SERVICE 		4
		X 88.126-26

MODEL **44, (444)**

CARBURETTORS

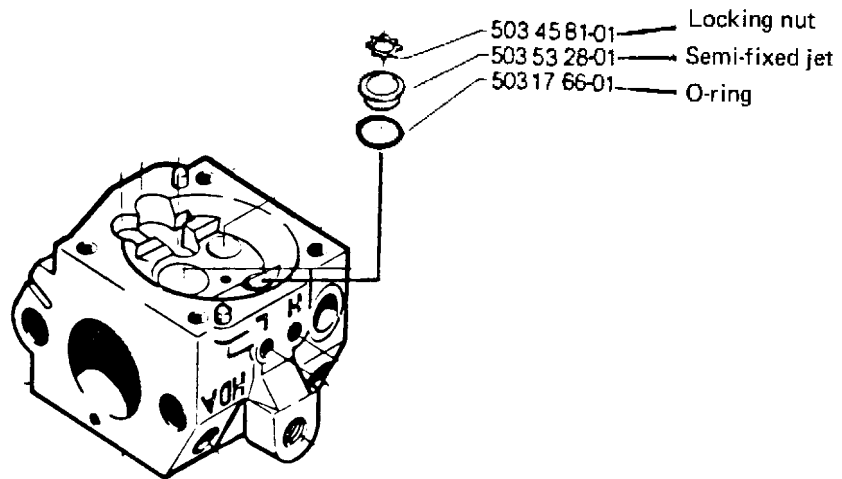
Carburettor type HDA 24 Ref. No. 501 79 80-01 is excluded and replaced by a "semi-fixed" carburettor type HDA 35 B Ref. No. 503 53 27-01. These carburettors are fully interchangeable.

Introduced from serial No. 44-8020271.

NOTE! When changing older carburettors type HDC 51 B Ref. No. 501 45 67-05 to HDA 35 B according to above, the following parts must be mounted also. See below.

Inform your customer that also the function of the starter throttle lock is moved to the choke lever. (See the model 44).

H = 1
L = 1 1/2
